Dynasty Sweaters (BD) Ltd (Extended Building)

1st April, 2018

ACCORD
on Fire and Building Safety in Bangladesh

Mismatch in as-built drawings

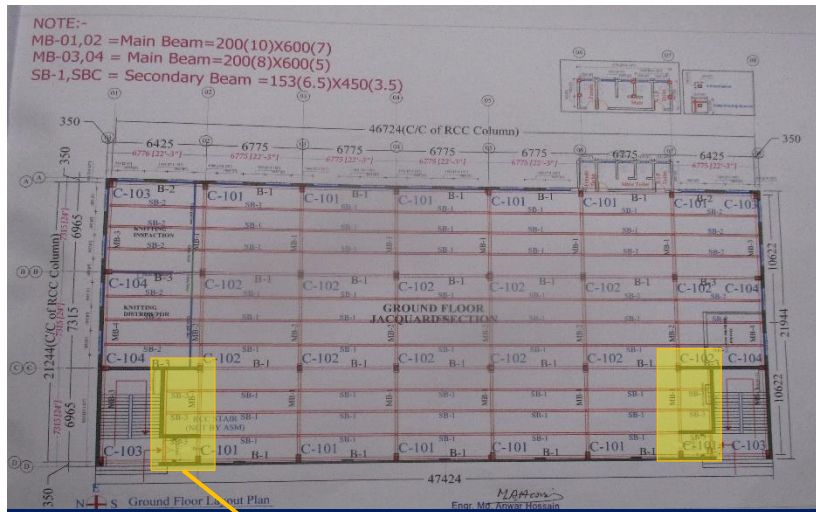
13mm dia cable bracings were found whereas as-built drawing shows 16 mm. Also no details were provided in as-built drawings for sub-beam near stair.

Missing Knee bracing & loose cable bracing

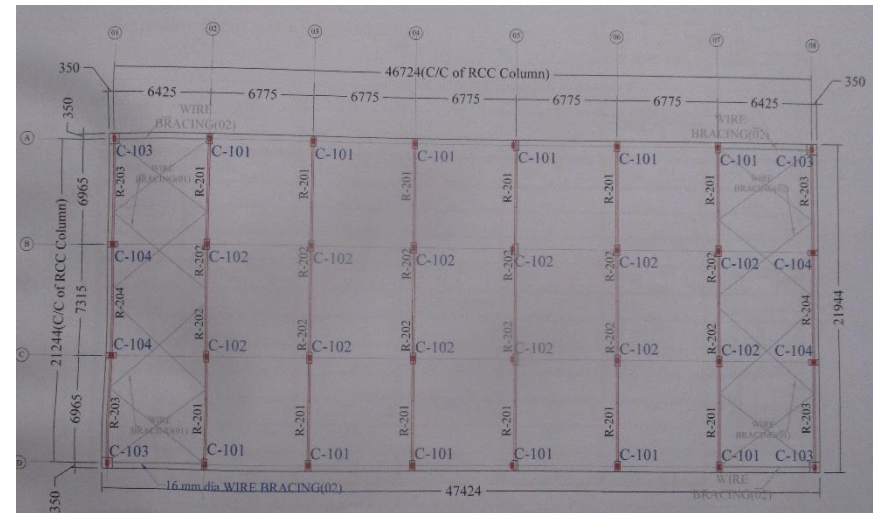
Gable Frame @ Grid :01&08

**Prepared engineering assessment
to be verified**

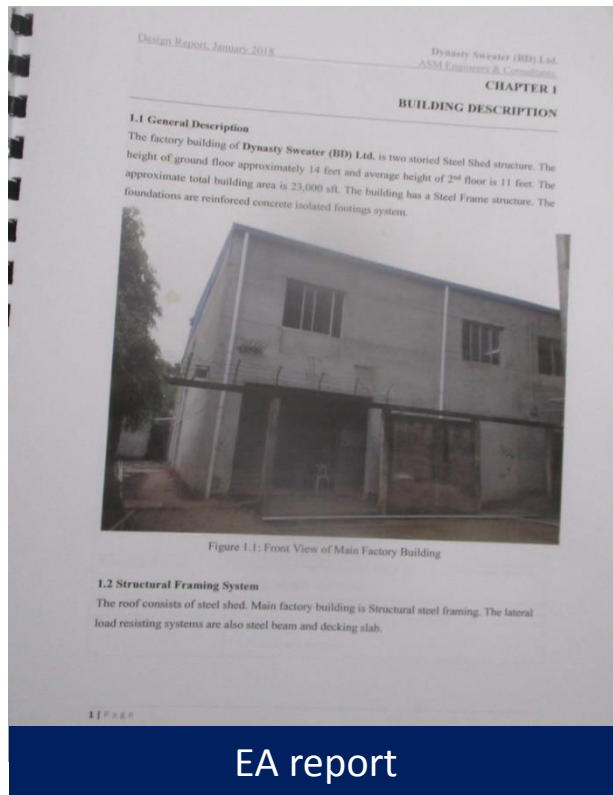
An Engineering Assessment (EA) has been prepared following BNBC for the two storied steel building. Some members are found over stressed in the FEM model. Also, EQ load combination wasn't considered. Factory is required to submit the revised EA to Accord for further review.
